Our Ref: 402.0036.00350: Table A

Application Reference DCC/2975/2010

Development of the New England Resource Recovery Centre, near Lee Mill, Devon, to include an Energy from Waste facility with a capacity of 275,000 tonnes per annum of residual Municipal Solid Waste (MSW) and Commercial and Industrial Waste (C&I) with bottom ash recycling, a non hazardous landfill; and associated visitor centre, ancillary offices, welfare, parking facilities, weighbridge/wheel wash; also new access road linking into the A38 at Lee Mill with new river crossing over River Yealm and associated aftercare and landscaping improvements across the whole site with associated woodland management plan.

Figure 2: Dome is monochrome, but appears to be different hues

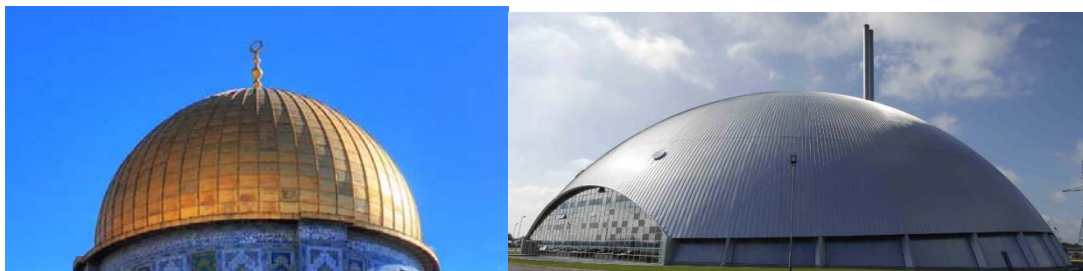
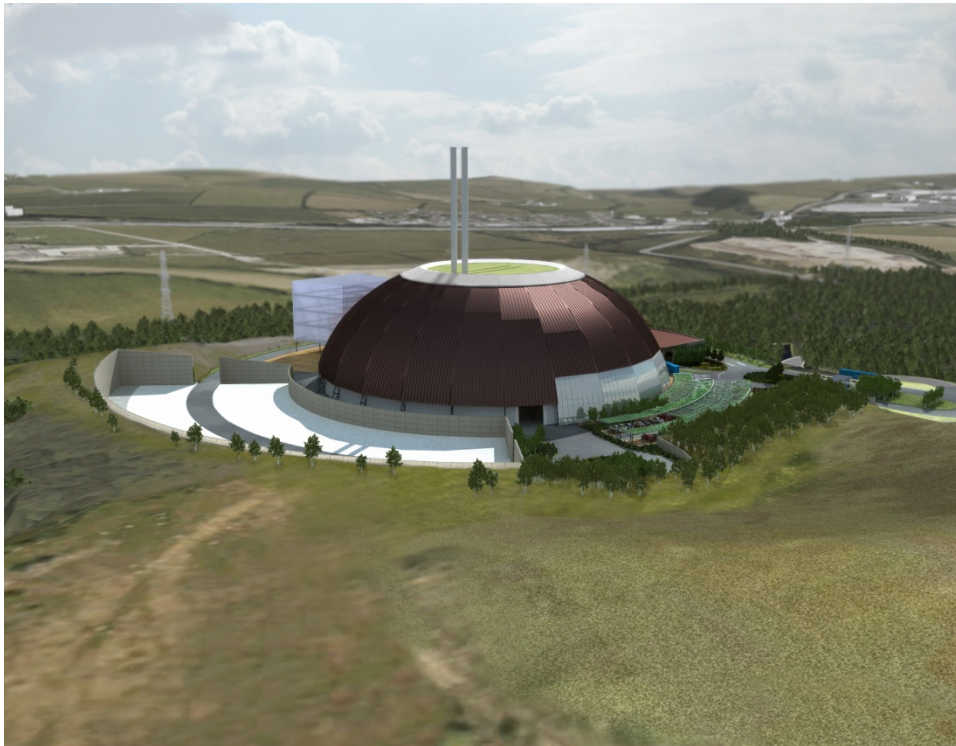
A45 More information is required concerning the potential reflectivity of the proposed construction materials.

The PVDF finish is described by Corus as having good gloss retention properties. This is considered to be a positive attribute of the finish in the context of the New England design, because it means that the finish will reflect light which in turn will bring variety to the colour of the material. The New England dome is made up of curved surfaces that will catch the light in different ways at any one moment in time. This principle is illustrated in the images of domes below, where the domes appear to be a variety of colours, but in fact are a single colour. The curved surfaces reflect light in such a way that the dome shape is revealed.

The appearance of the New England dome will change throughout the day as a result of the changing light reflecting off the dome's curved surfaces. Because the finish has a degree of reflectivity, the colour of the dome will also change from the base to the top, meaning that it will blend well into its setting because it responds to the setting and the changing light conditions. Refer to figure 3 below. These subtleties of changing colour and appearance would not be as successfully achieved with a matt finish.
